Auburn Solar, LLC requests that the City of Auburn Planning Board grant a minor Site Plan Amendment to the Auburn Solar project, allowing it to reduce its generating capacity from 1.99MW_{ac} to 0.99MW_{ac}. Additionally, Auburn Solar requests that the Planning Board extend the project's Special Permit by two years to March 2026.

AUBURN SOLAR LLC

AUBURN 0.99MW **SOLAR ARRAY** NORTH RIVER ROAD AUBURN, MAINE

Auburn Solar Site Plan Comparison

SITE PLAN AND **DETAILS**

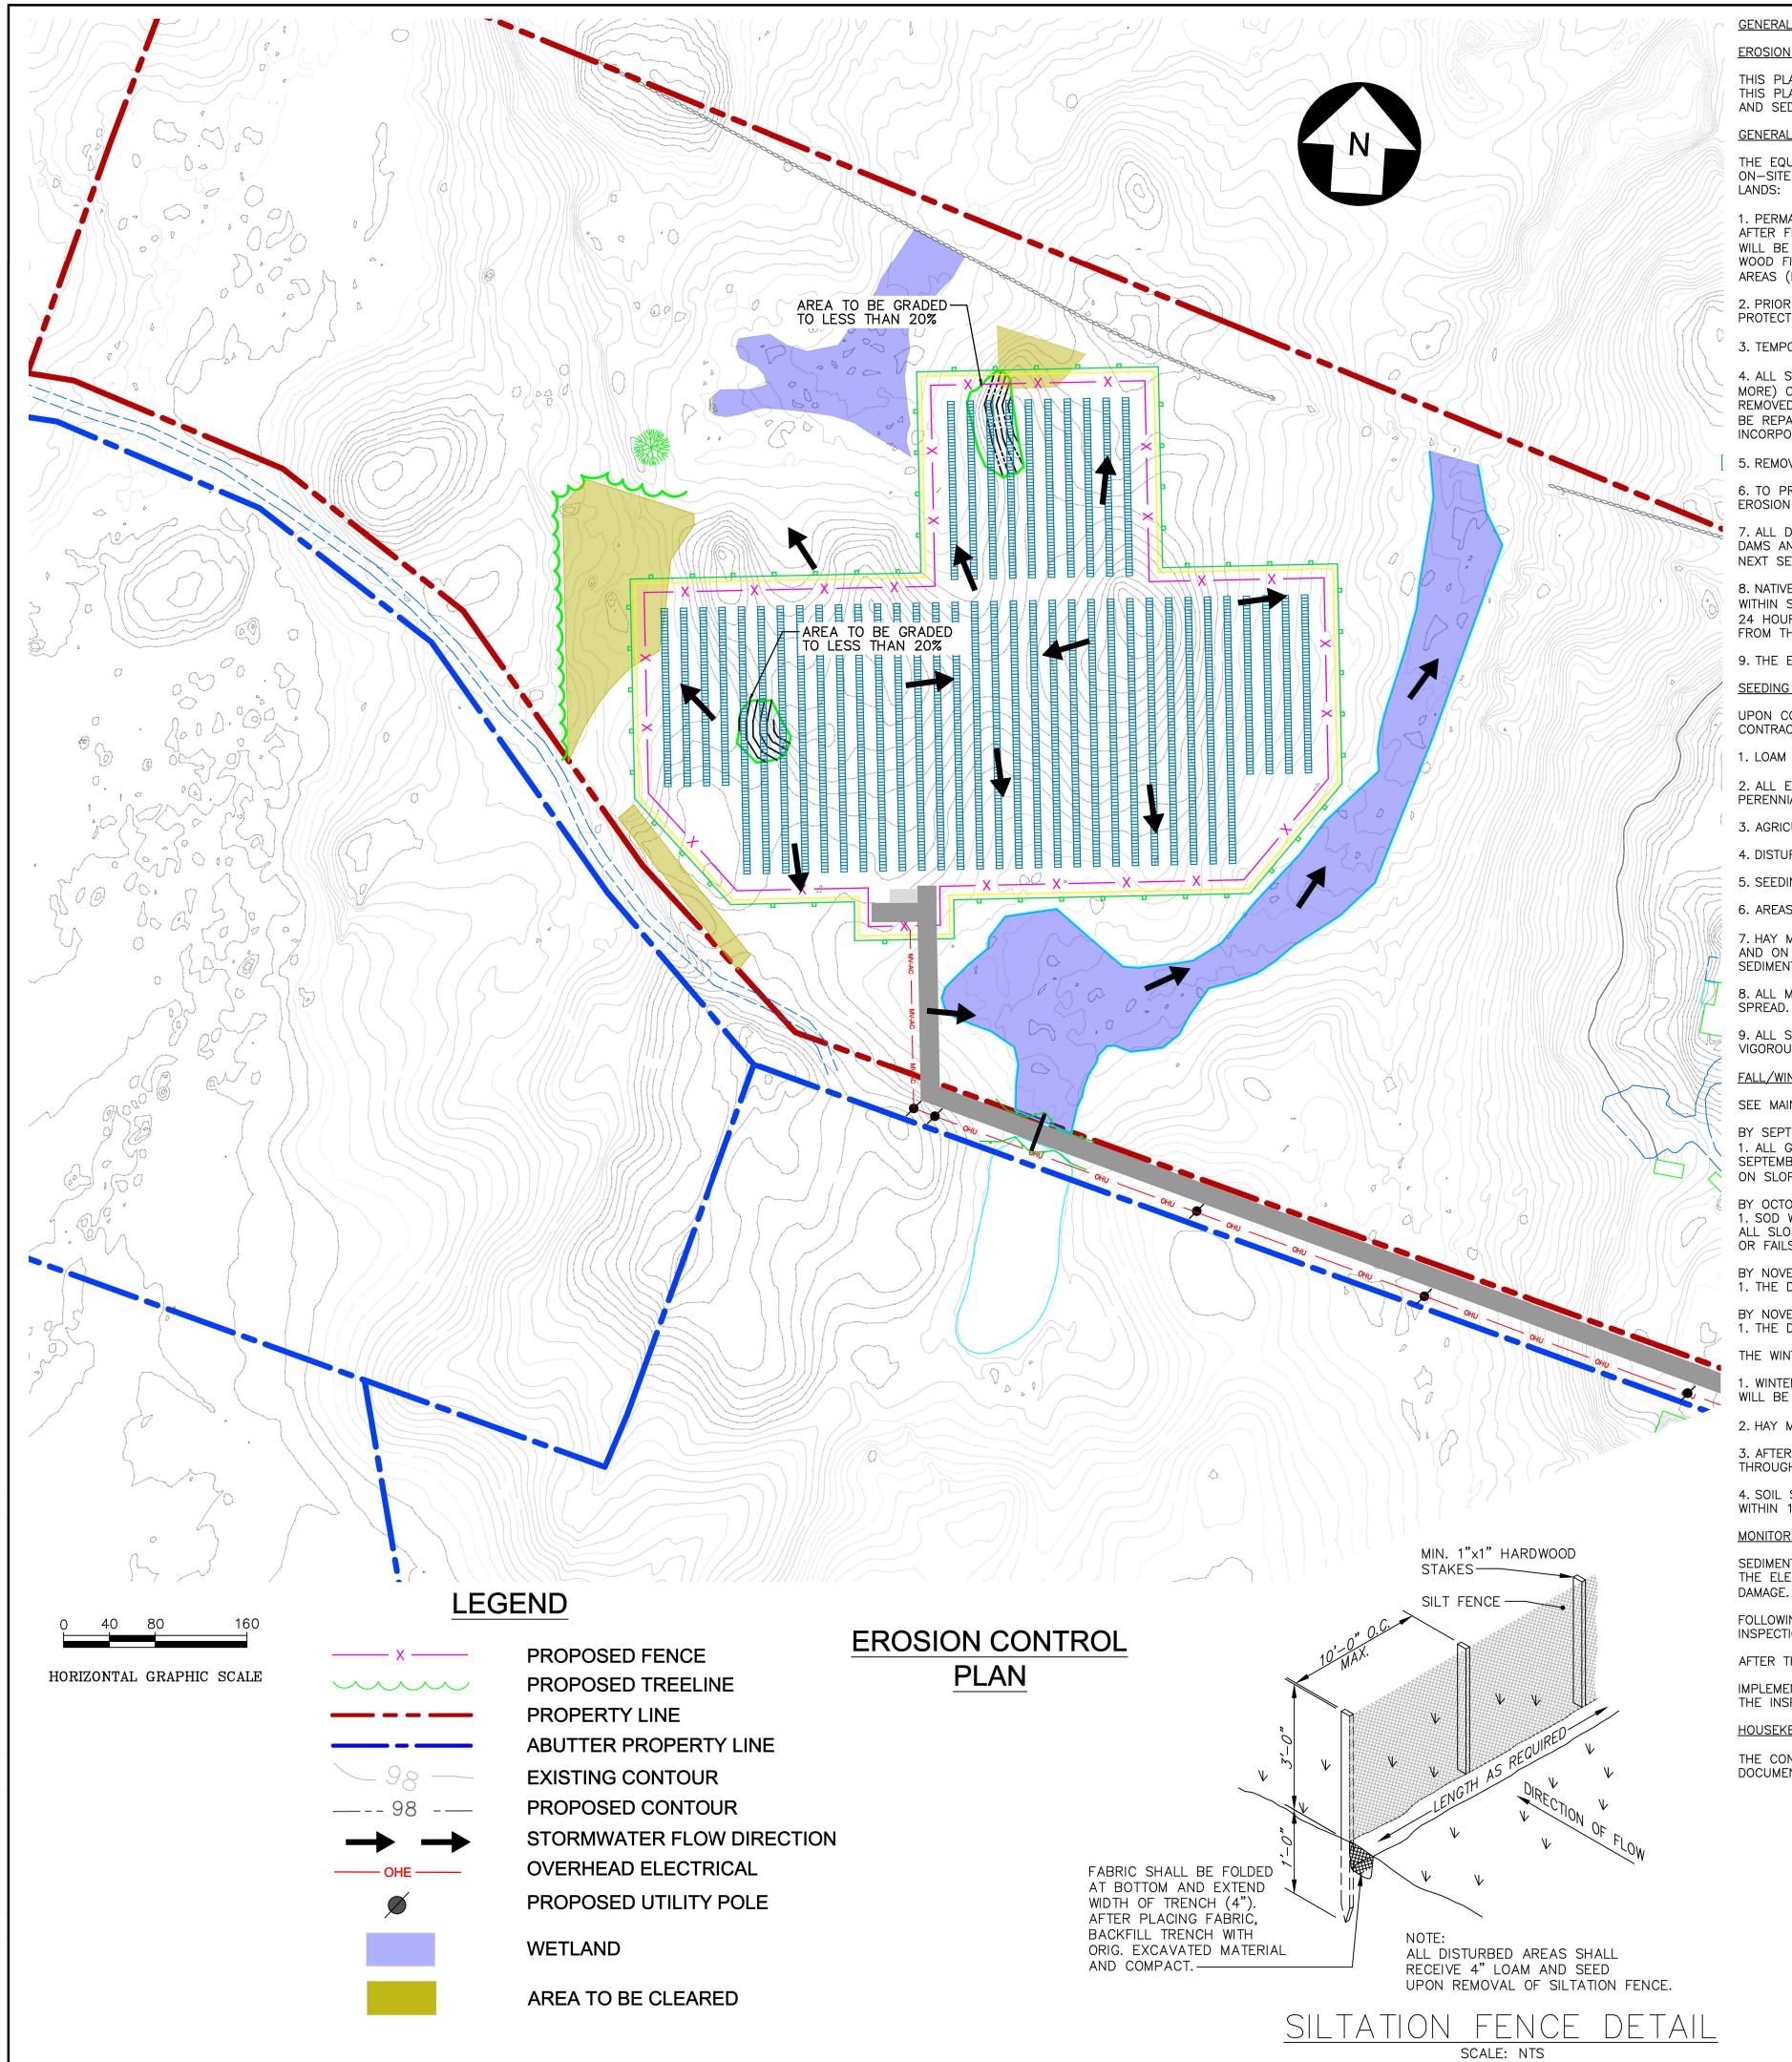
6. WETLANDS: THERE WILL BE NO WETLAND ALTERATION (DIRECT OR INDIRECT) AS A RESULT OF THIS PROJECT

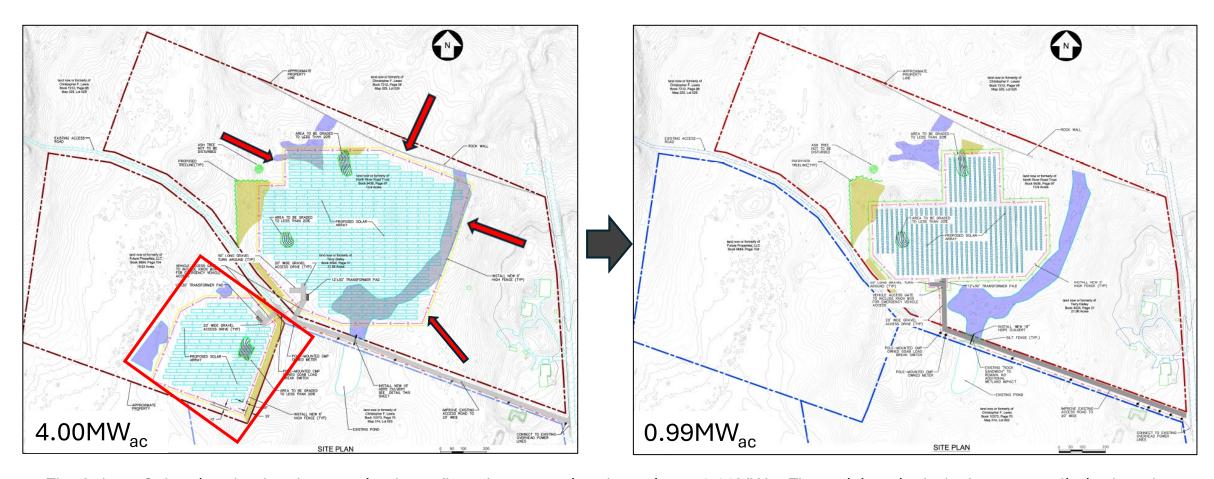
The Auburn Solar site plan has been revised to reflect the generation downsize to $0.99MW_{ac}$. The revisions include, but are not limited to, the removal of the southern parcel and the reduction of the solar array footprint, thoughtfully designed to avoid delineated wetlands.
